To: INCITS T10 Committee
From: Susan Gray, Quantum
Date: February 2, 2004
Document Number: T10/03-369r2
Subject: ADT State Diagrams

Section 4.3 and 4.4 can be made more readable by providing state diagrams and describing the transitions.

This proposal applies to ADT Revision 9a.

Figure x State machine conventions

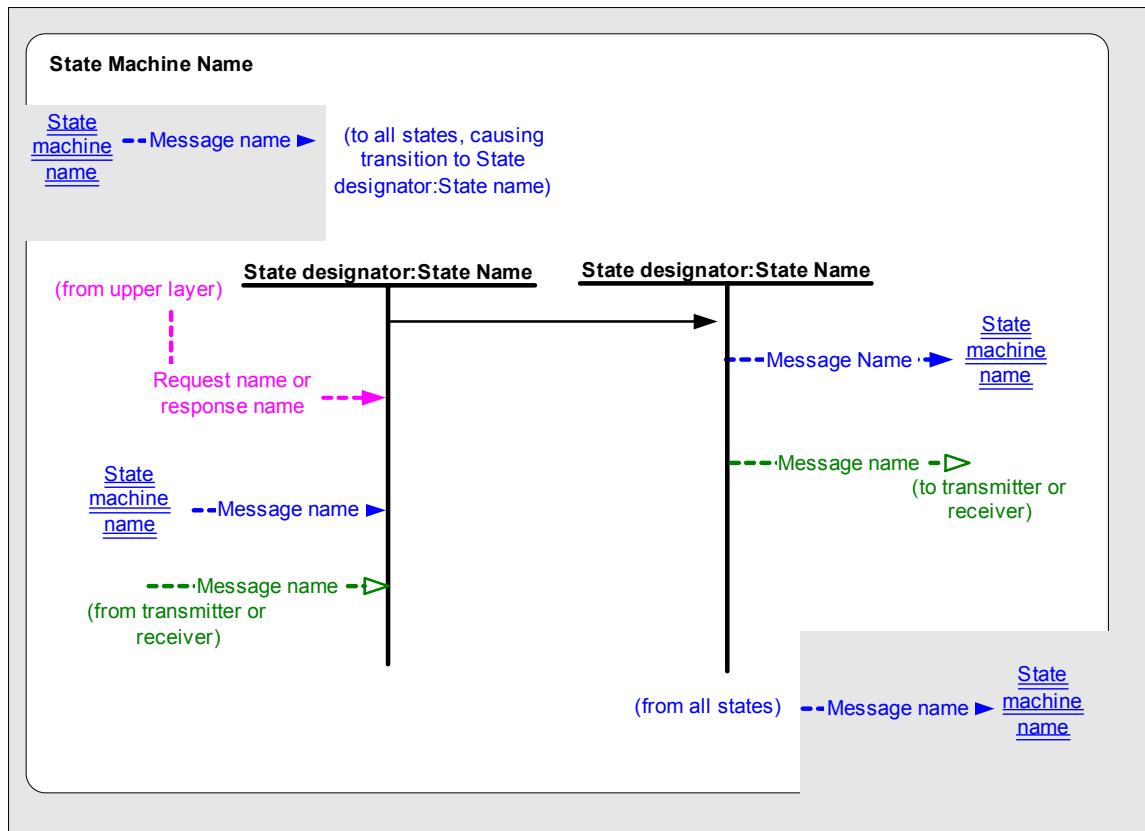
Add state machine convention section

Figure x shows how state machines are described.

Figure X + 1 Port State Machine Diagram

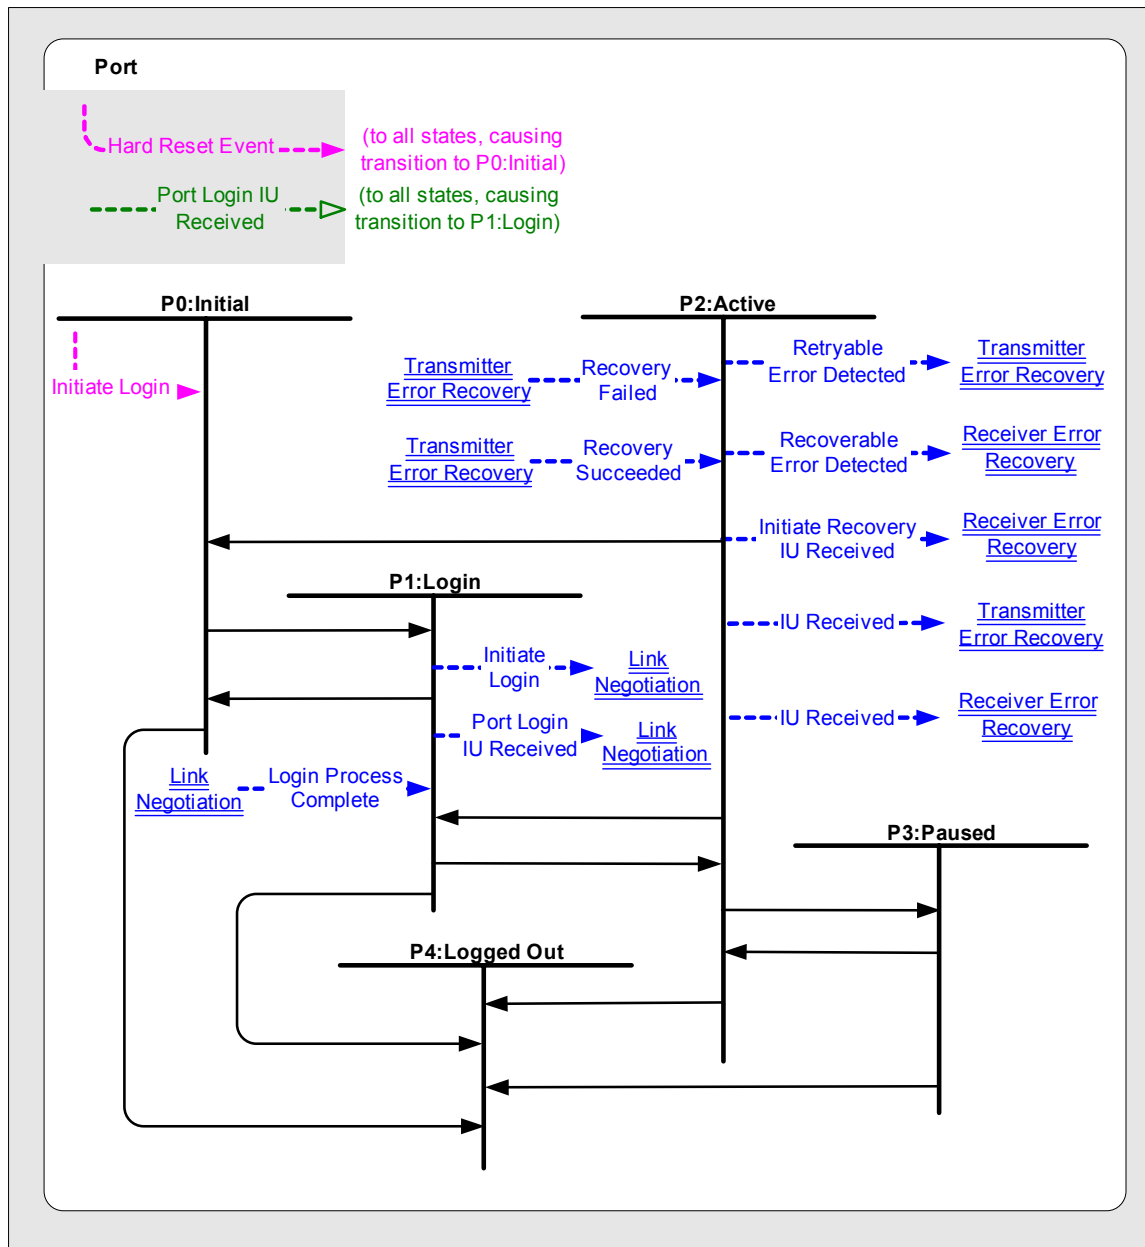
Globally change P3:Pending Recovery to R1:Pending Recovery

Globally change P4:Initiating Recovery to T1:Initiating Recovery.

Globally change P5:Recovering to R2:Recovering.

Globally change P6:Paused to P3:Paused.

Globally change P7:Logged-Out to P4:Logged-Out.

(Replace the entire contents of section 4.3 and 4.4 with the following sections.)

Figure x + 1 shows the port state machine. The following subclauses describe the transitions and the actions taken in each state.
